**STATION NORTH AND STATION SOUTH SITE WITHIN THE NORTH RYDE
STATION URBAN ACTIVATION PRECINCT (SSD 6265)**

Thank you for your letter dated 8 April 2014 inviting Transport for NSW (TfNSW) to comment on the above. Please accept this as a joint TfNSW and Roads & Maritime Services (RMS) response.

Annexure A

North Ryde Urban Activation Precinct Station Site North and Station Site South

Figure 11.1 Potential bus routes through the M2 Site and Station Sites

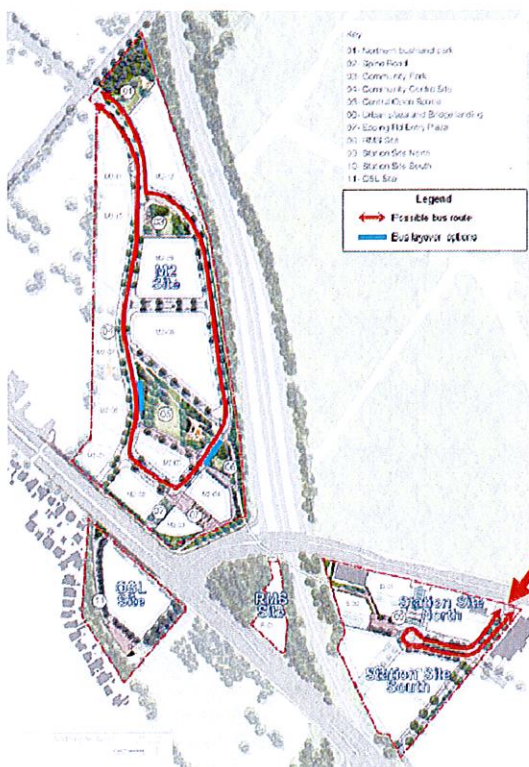
The 2012 TMAP clearly references bus turn around being provided in Station Street. Page 149 from the 2012 TMAP shows this below. The TIA states that it will now not be possible for a bus to turn around within the dimensions proposed for the Station Street cul-de-sac. UGNSW and the private proponent of the Station Site North have advised that this is necessary to accommodate the foot print of the proposed development.

Bus access to Station Street was envisaged in the original TMAP

UGNSW has suggested that Julius Avenue could be used as a bus turn around area. This proposal has been noted by TfNSW who have advised in return that this option increases service kilometres. Balanced against this it is also noted the Julius Avenue extension brings bus services closer to potential patronage generators including Riverside Corporate Park.

On balance TfNSW is accepting of the UGNSW/Country Garden position that buses cannot now be accepted in Station Street without a range of significant compromises in other areas. TfNSW has indicated it may seek to re-balance services so that more services are directed to the M2 Site while comparatively fewer of the services will be directed to Station Site South. UGNSW should recognise this will increase the need for supporting infrastructure in the M2 Site. This will or may include bus stops, bus layover, driver/toilet facilities and potentially a covering canopy on the pedestrian bridge. UGNSW and their development partners should also commit to recognise the need for the road network comprising Road 38, Road 18 and Julius Avenue to be connected and built to a standard able to accommodate the swept path of 14.5 metre non-rear steer buses. TfNSW also requests that a layover area be provided on these roads to accommodate two (2) 14.5m buses with draw in/draw out space. This will achieve practical achievement of Section 4.1 D of the North Ryde DCP *Ensure connector streets are designed to accommodate movement of buses.*

UGNSW commits to the following:

- An assurance Road 38, Road 18 and Julius Avenue will be provided for bus turnaround inclusive of swept paths for 14.5m non rear steer buses and two bus layover spaces for 14.5 metre buses.
- Bus stops, bus layover, driver/toilet facilities to be committed to in the M2 site. UGNSW to undertake and report on the costs involved in providing a covering canopy on the pedestrian bridge from the M2 Site to North Ryde Station.
